Re: Initial Submission Review

Nick's Convenience – Jackson Gap at Porteos

Site Plan and Plat Application Number: DA-1903-35

Initial Submission Review

LANDSCAPE SPECIFICATIONS & DETAILS

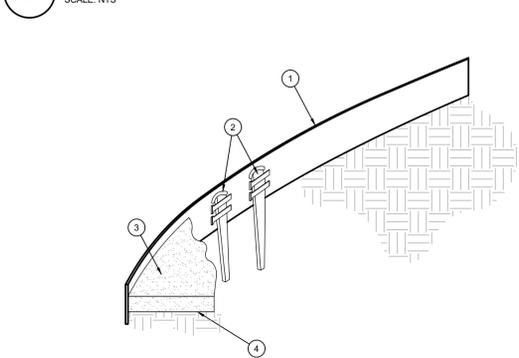
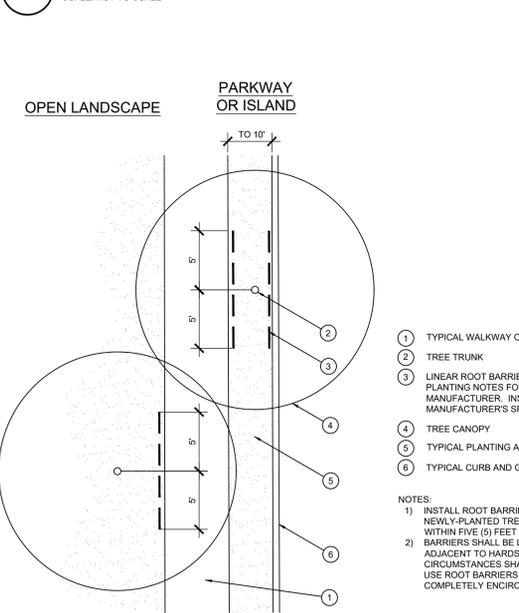
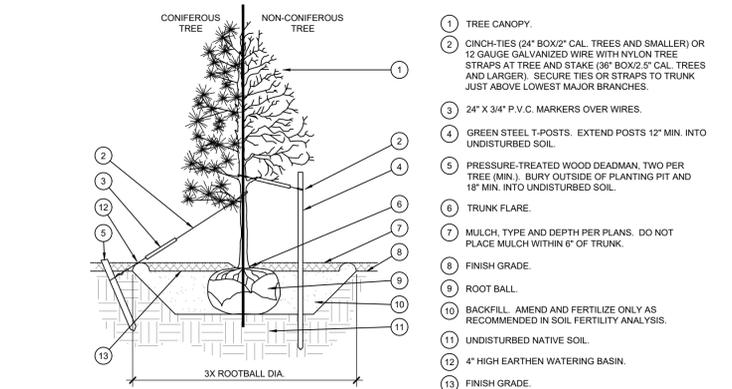
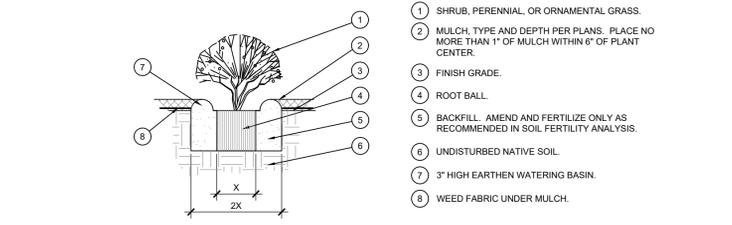
Remove the specifications as the city does not review landscape construction drawings.

EDG Response: The specifications have been added as requested.

DRAWING TITLE
EXTERIOR ELEVATIONS

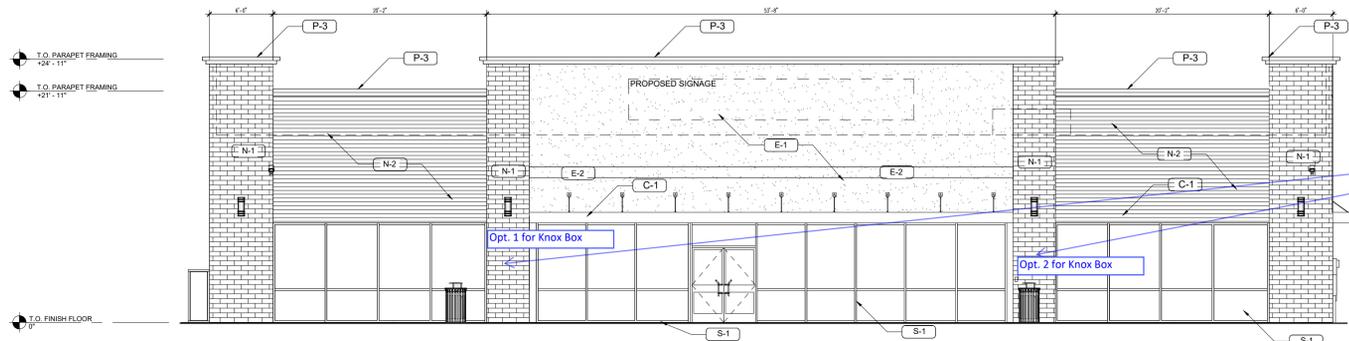
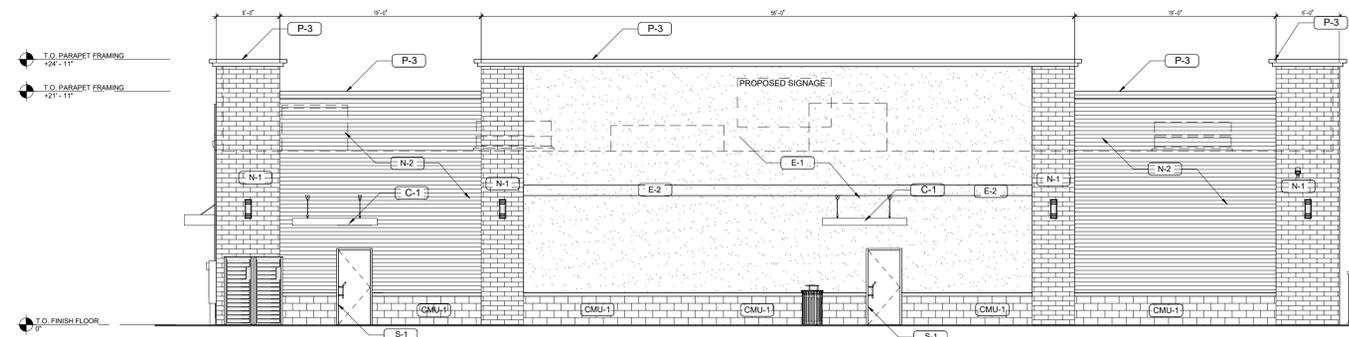
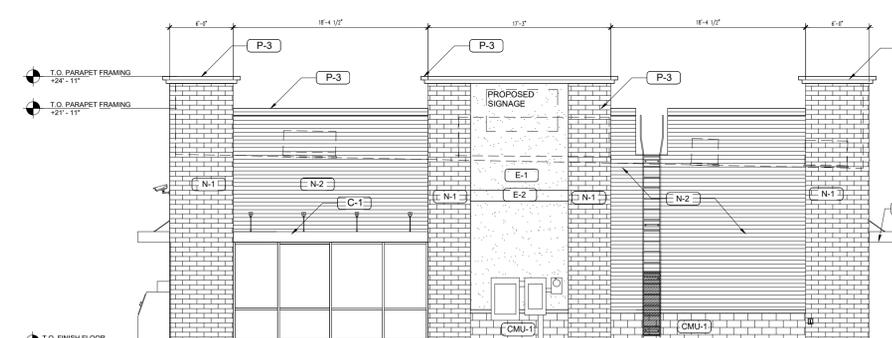
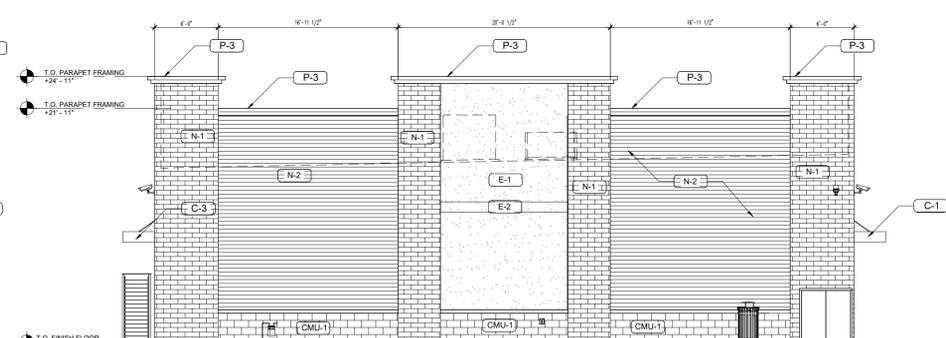
- 6G. A roof form or height variation is required for roofs, including canopy roofs. A variation of at least 3” in height is required every 60 ft, so this will only be needed on the front and rear elevations.
A cornice feature that projects from the canopy has been added.

12DD. Identify and label any exterior storage of CO2 bottles, ice machines, or LPG cages. Show vehicle impact protection.

Any exterior storage facilities, as applicable, have been added to the Site Plan.

Figure 1
SITE LOCATION

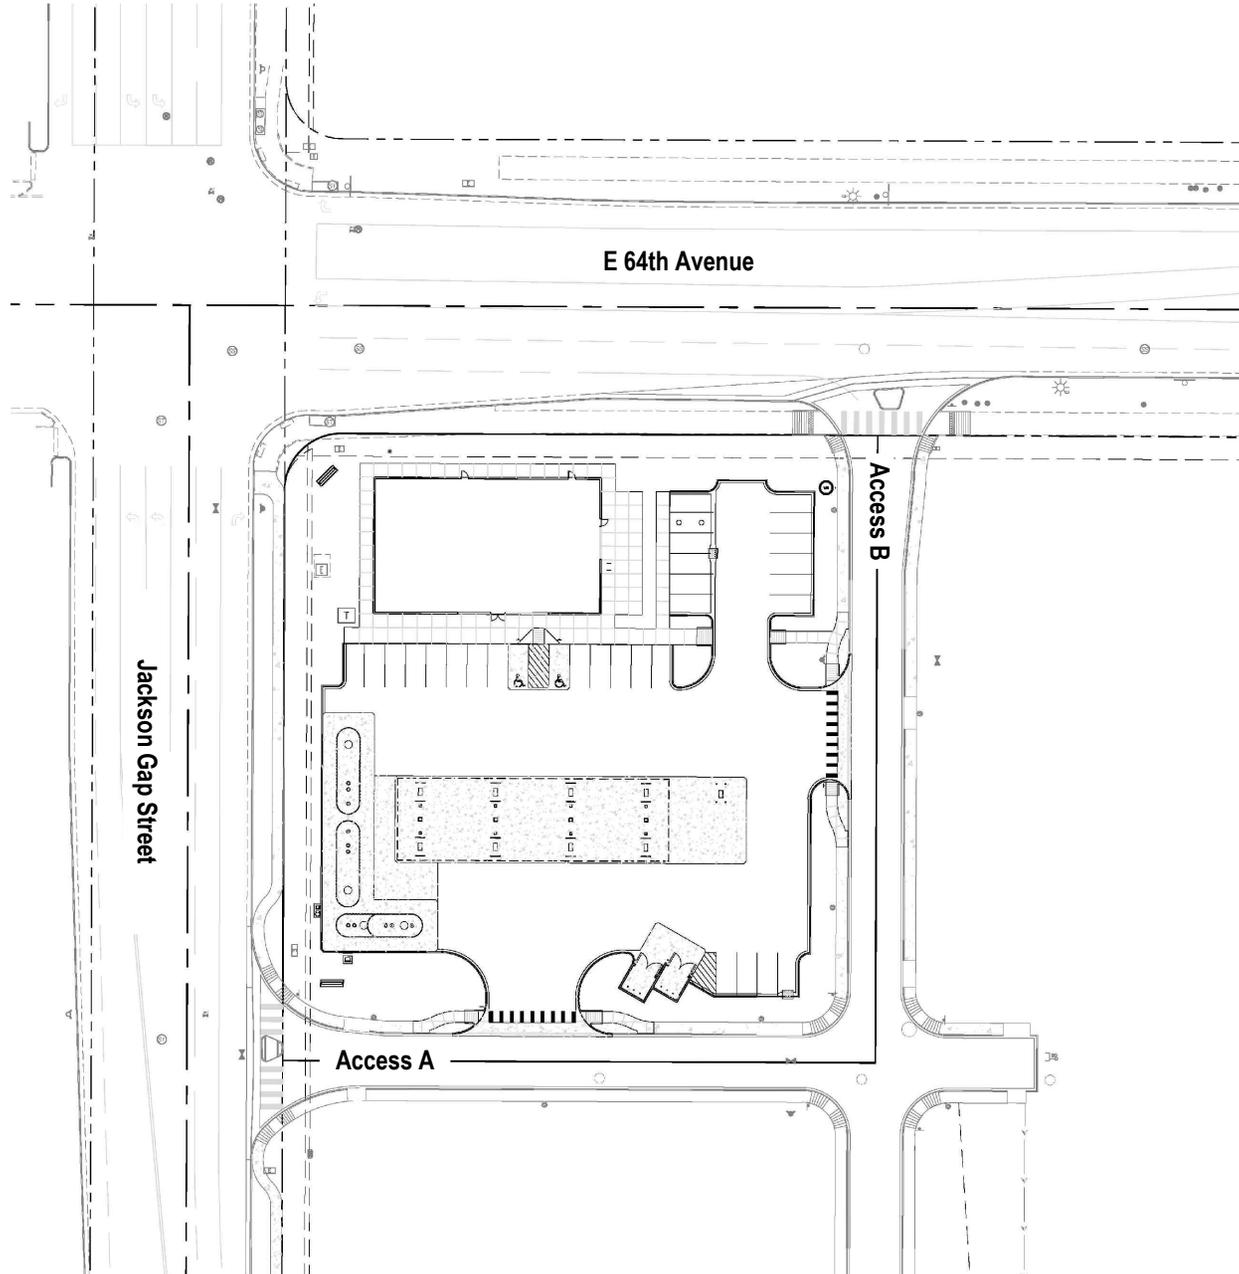
this discussion is not consistent with what Porteos PA 9A/9C TIS shows for lot 1 (16 pump/3,500 sf convenience store) - where does the Strip Retail Plaza come from?
